ADVISORY NOTICE

Users have commented that, in some circumstances, it is not obvious how to correctly insert the COBRA scrubber.

Figure 1 - Cross section of COBRA scrubber

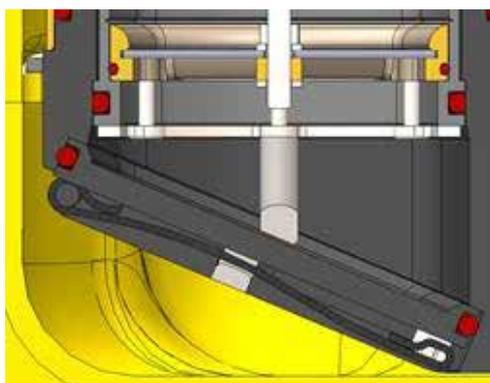
Each user has their own method for handling and securing COBRA sets in the bell for changing the scrubber cartridge. Depending on the chosen orientation of the COBRA set for this procedure, it is possible to inadvertently insert the cartridge upside down. This will make the door difficult to re-fit. However, it is possible to fit the door to the point where it is possible to force in the staple. This will cause damage to the staple groove and may cause the door to detach during use.

One purpose of the angled handle is to support the scrubber in the correct position (see Figure 1). For this reason, it is not advisable to modify the existing handle so that it does not contact the door.

Short term- Users must take extreme care to fit the scrubber door and staple correctly. If the door or the staple do not appear to fit correctly, the orientation of the scrubber must be checked. Under no circumstances must the staple be forced in.

Longer term - JFD will make available a modified handle, part number DB5003378, which users can purchase and fit if they encounter this difficulty. This handle will provide the required support to the scrubber but will not obstruct the door in either orientation.
